Sanitary Sewer System Expansion Feasibility Study

Town of Lyons

SUBJECT: Response to comments, September 1 draft submittal of the Sanitary Sewer System Expansion Feasibility Study

Riverbend Plan and Profile

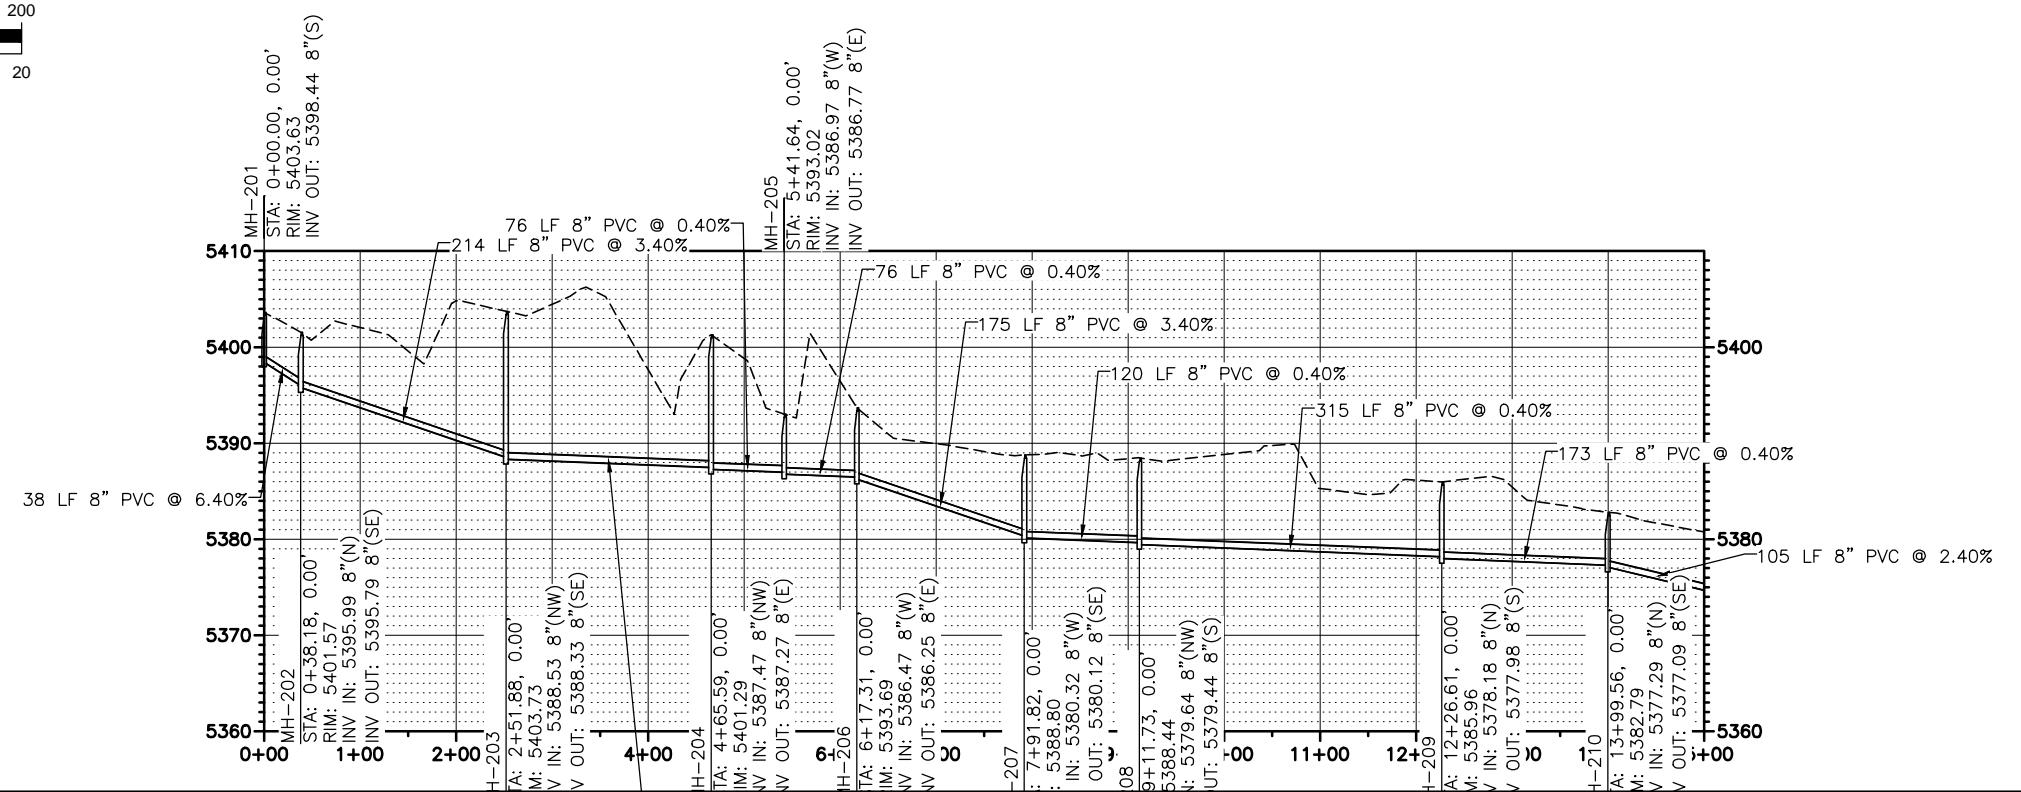
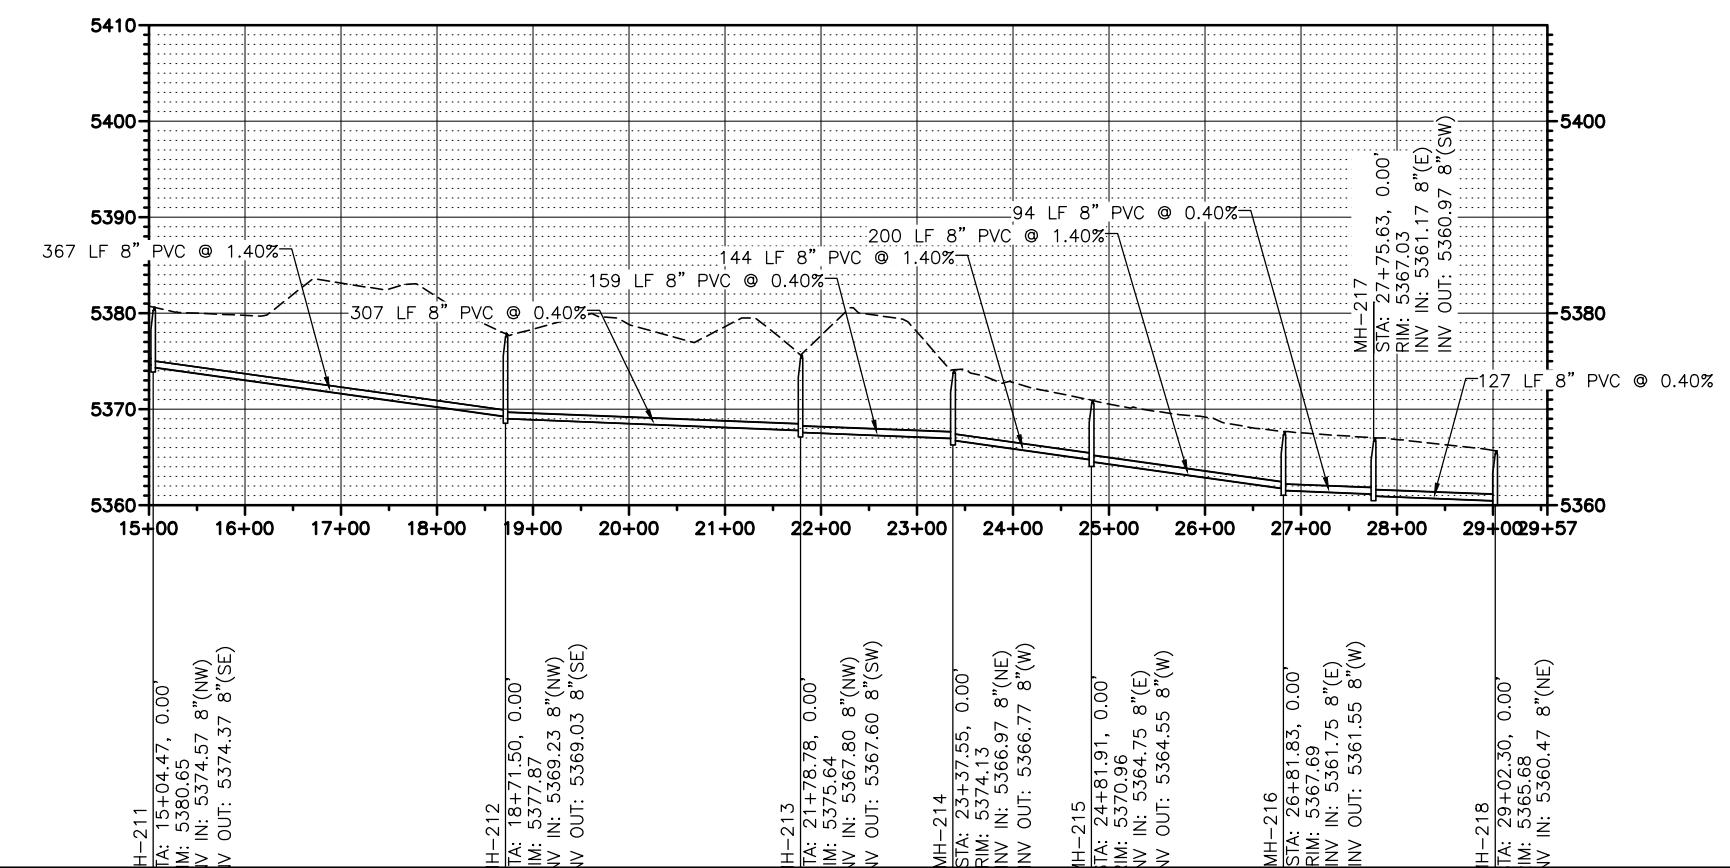
Comment: Provide an exhibit showing the potential, or lack there-of, for a gravity sewer from 501 Main (Riverbend) that is routed from the gravity point of connection in the southwest side of this parcel, under US36 and along the alignment of the existing force main, under N St Vrain Creek on the east side of US36, then splitting north to the lift station and west to Apple Valley. The report identifies a portion of this routing through the escarpment, however this suggested routing would be out and around the escarpment to the east in the location (horizontal) of the existing force main, but vertically deeper as allowed by the new POC in Riverbend.

Response: This has been investigated. Discussion and exhibits are included in the revised report.

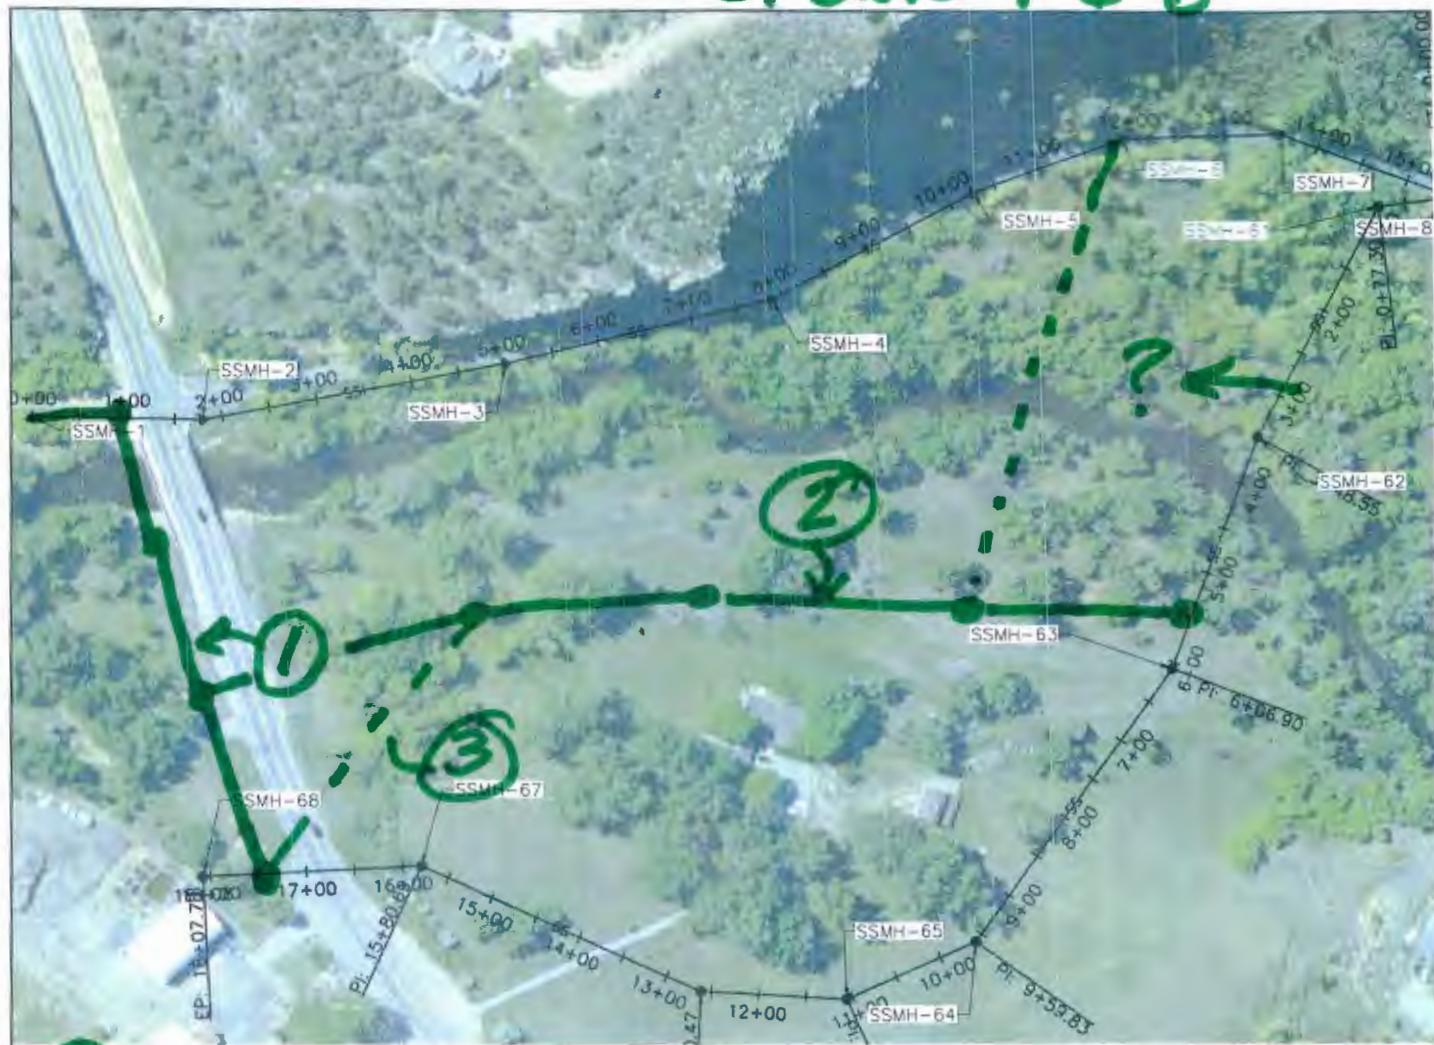
- For Groover area only, include map and discussion about connecting to the Eagle Canyon gravity sewer system on the north side of US36. The outfall is located near the southeast corner of the Eagle Canyon subdivision as shown on the referenced drawings for this area and included with this response. This option would only serve the Groover area, not the rest of the N St Vrain Drive lots that would remain separate as per the discussion and information provided.

Markup of NLPA Map RE: Groover - This has been investigated. Discussion is included in the revised report.

RE: SHTS 1 & 6

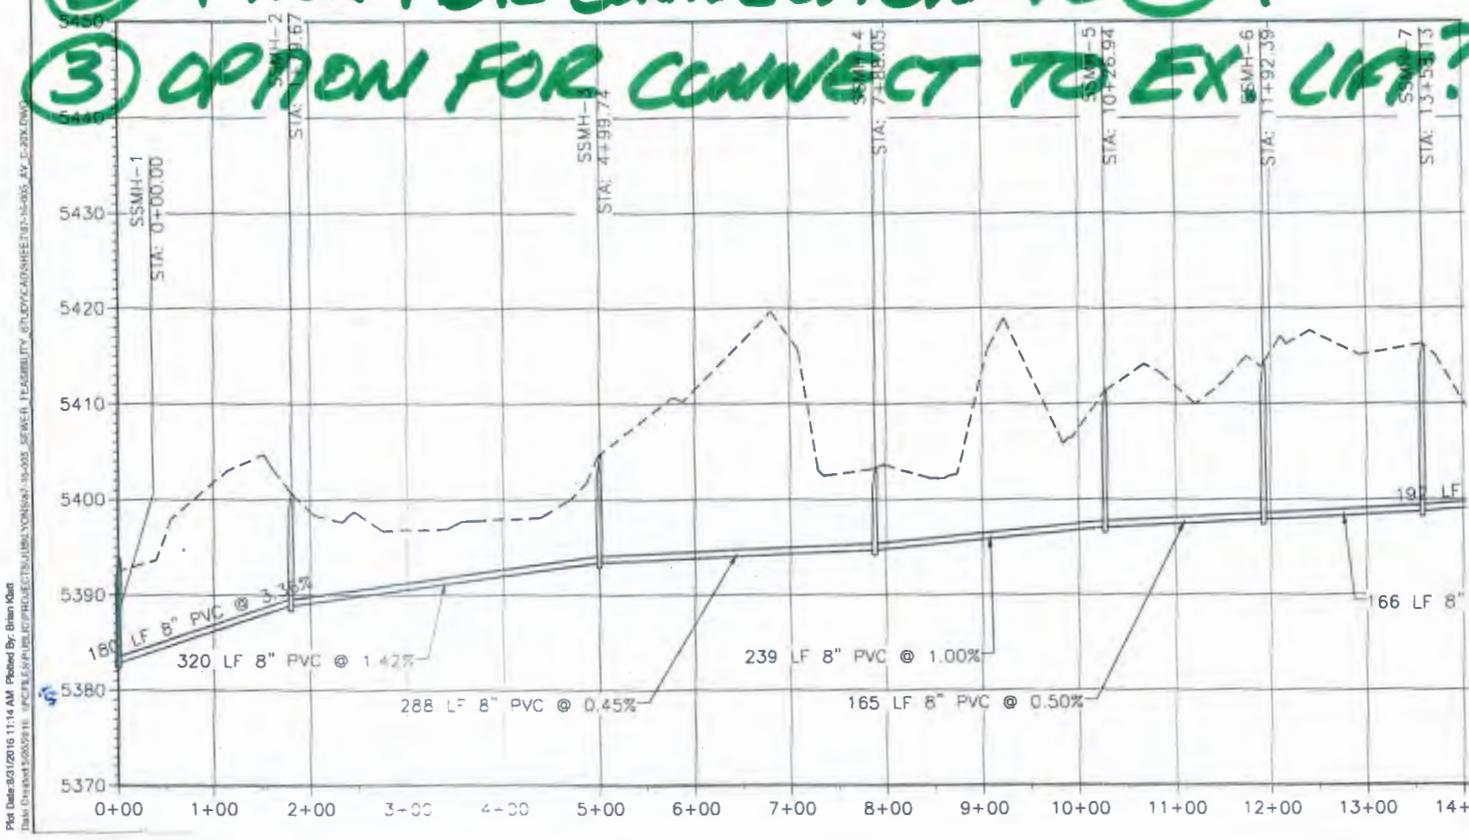
① CONTINUE FROM RNERBEND
② OPTION FOR CONNECTION TO ①?
③ OPTION FOR CONNECT TO EX CIR?

Markup of P/P Sheet (including comments and notes RE: Sheet 6) – discussion of an alignment from the existing lift station to Riverbend has been added to the report, along with an exhibit. Although other permutations are possible, a sewer aligned from the lift station to Riverbend would serve all of Apple Valley by gravity, including the Eagle Canyon subdivision and Groover Drive. Alignment 2 could be investigated as part of a design study for a sewer in Apple Valley. Alignment 3 would not work, due to adverse grade. The alternative alignment we show crossing this property on our exhibit was chosen to maintain grade to the lift station while avoiding excessive trench depths.

Exhibit of Sewer Alignment

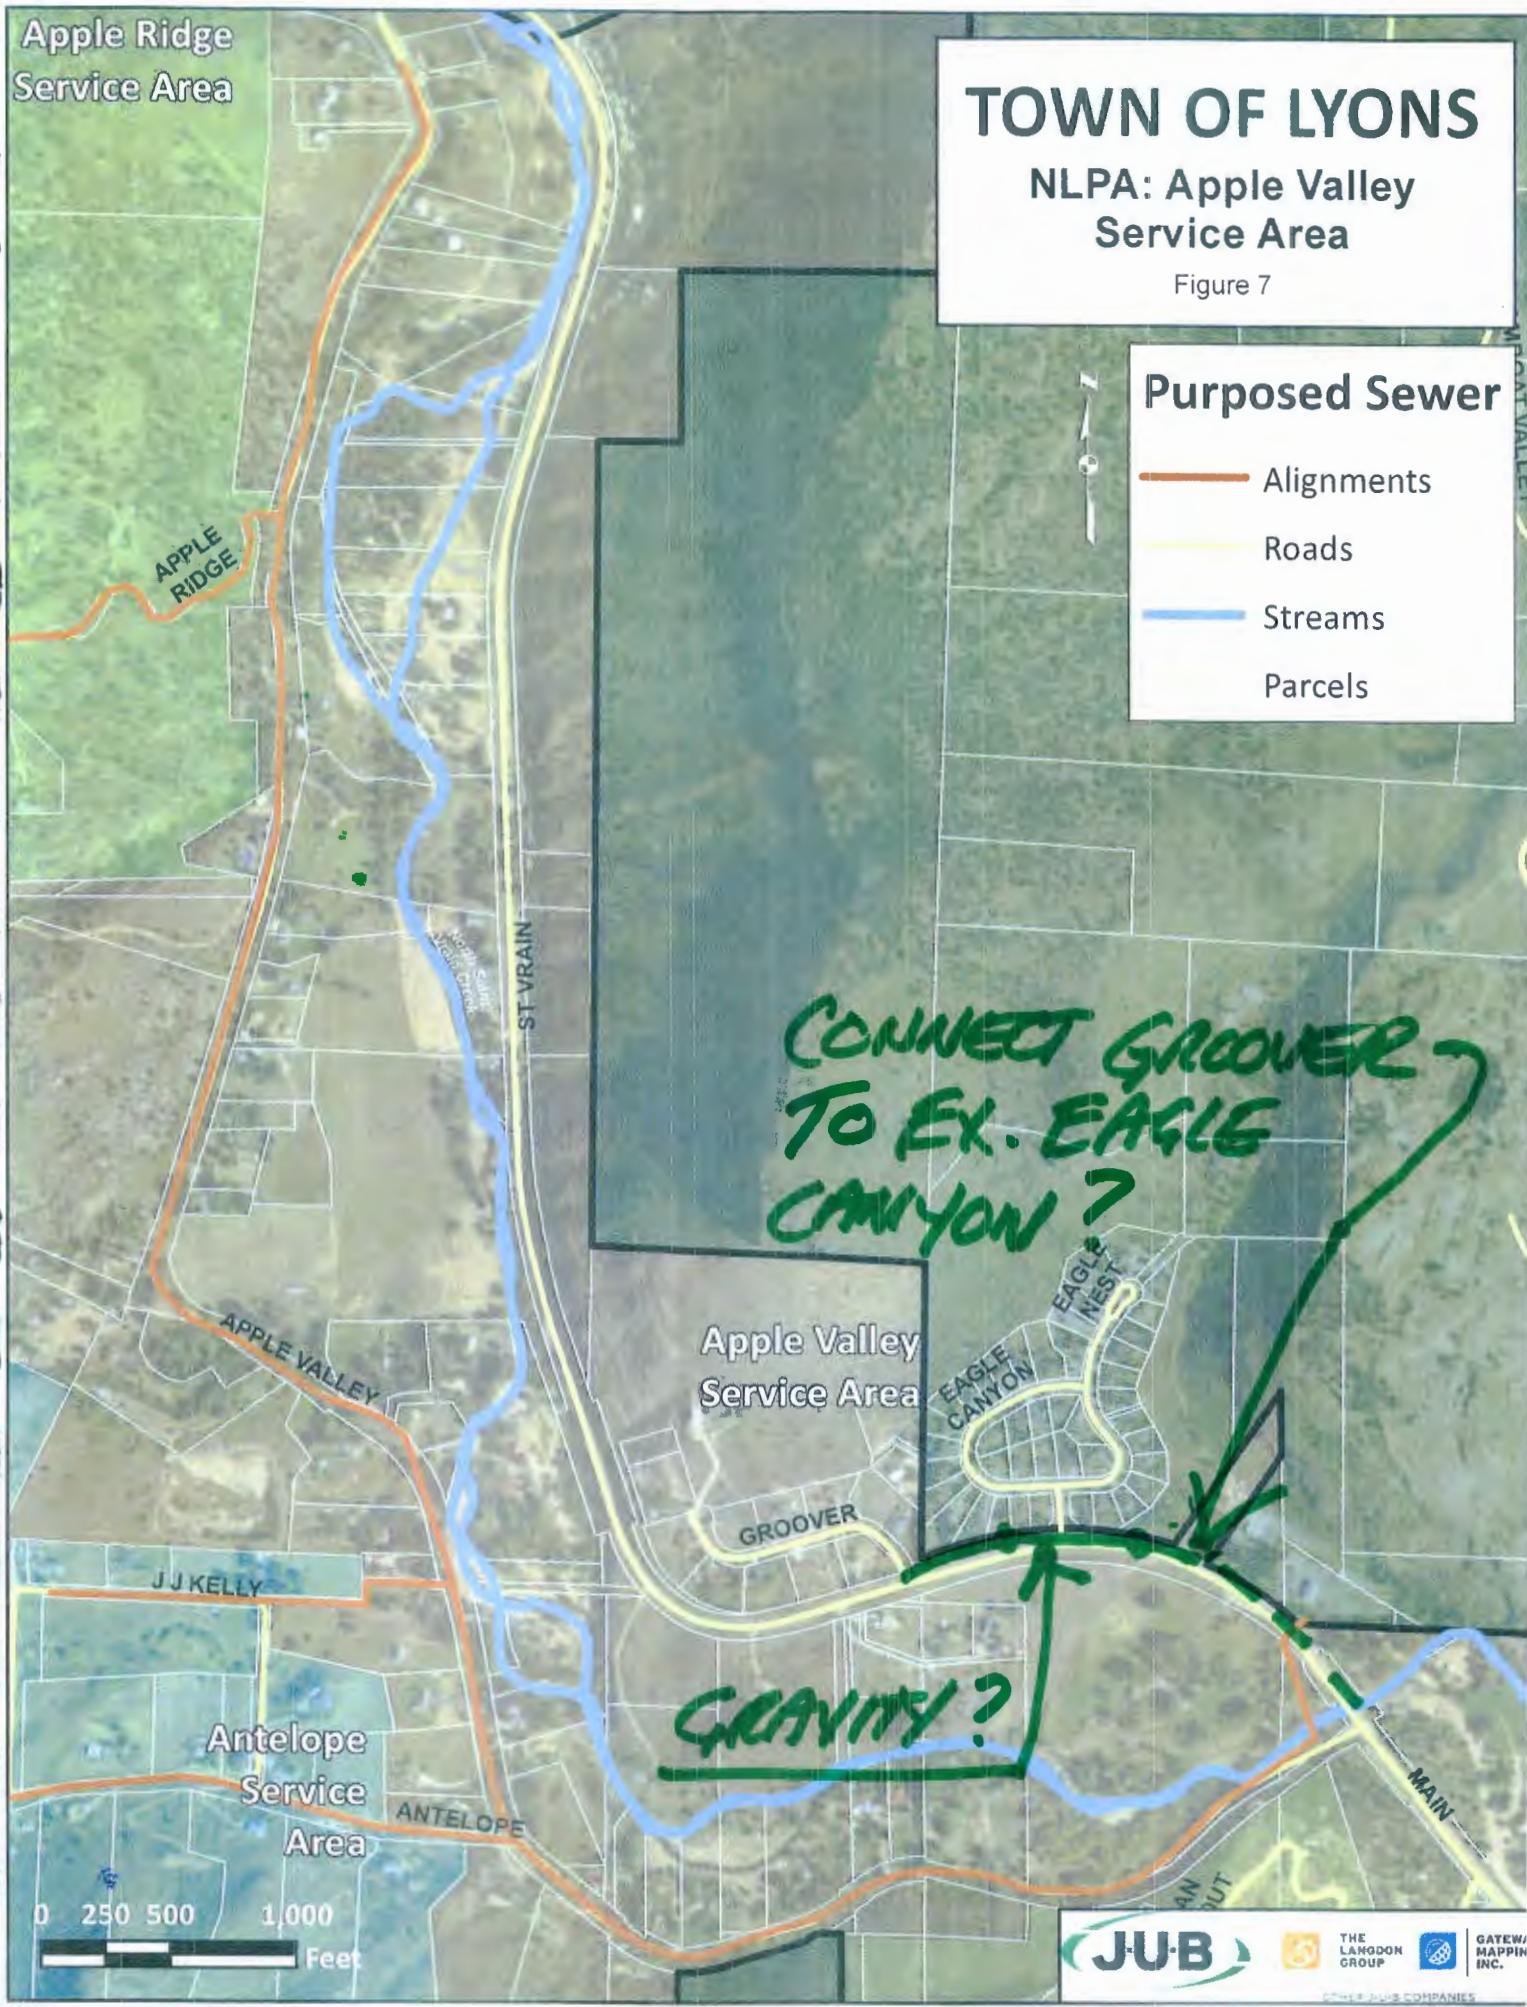
- Provide an exhibit showing the potential, or lack there-of, for a gravity sewer from 501 Main (Riverbend) that is routed from the gravity point of connection in the southwest side of this parcel, under US36 and along the alignment of the existing force main, under N St Vrain Creek on the east side of US36, then splitting north to the lift station and west to Apple Valley. The report identifies a portion of this routing through the escarpment, however this suggested routing would be out and around the escarpment to the east in the location (horizontal) of the existing force main, but vertically deeper as allowed by the new POC in Riverbend.

Exhibit of Sewer from Riverbend through Planet Bluegrass – This has been investigated and an exhibit and discussion have been included in the report. It appears feasible to serve Apple Valley by gravity via a sewer connecting to the existing sewer at Riverbend.
